BCA ASSESSMENT REPORT

**Oakdale South
Horsley Park**

Client: Goodman Property Services

Revision 2

Figure 1 – Areas of Non-Compliant Perimeter Vehicular Access per BCA C2.4.

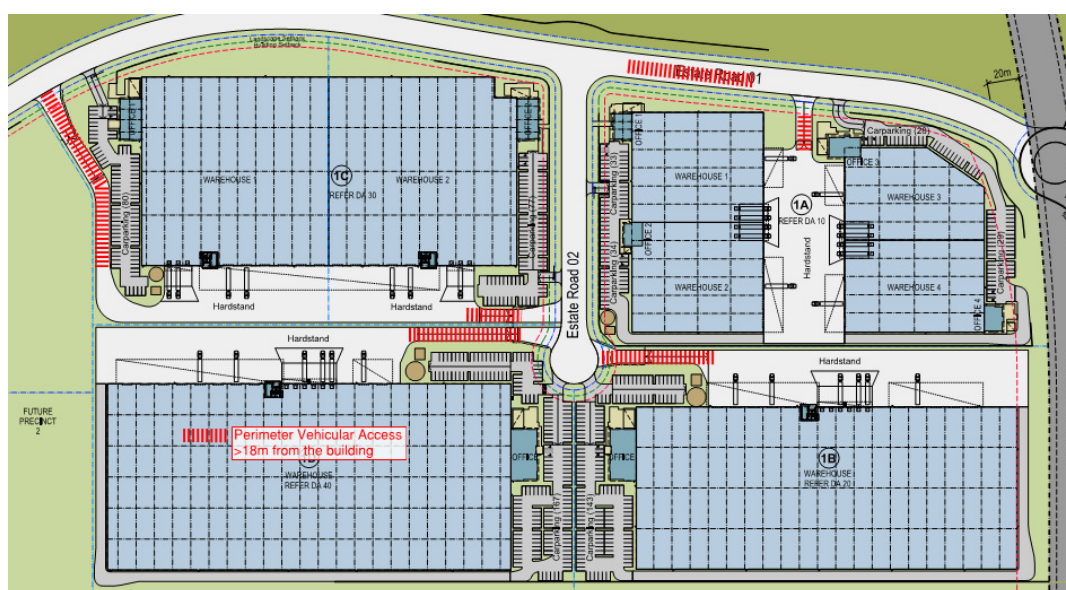
Comments: The proposed warehouse buildings do not comply with the provisions of C2.4 and thus the following non-compliance issues are required to be addressed as an alternative solution by the Fire Safety Engineer to demonstrate compliance with Performance Requirement CP9 - refer to the dot points and the diagram below for details of the proposed non-compliance issues:

- Vehicular Access is provided around the four (4) sides of all of the Warehouses & however, it is greater than 18m from the external walls of all the building- refer to diagram below.
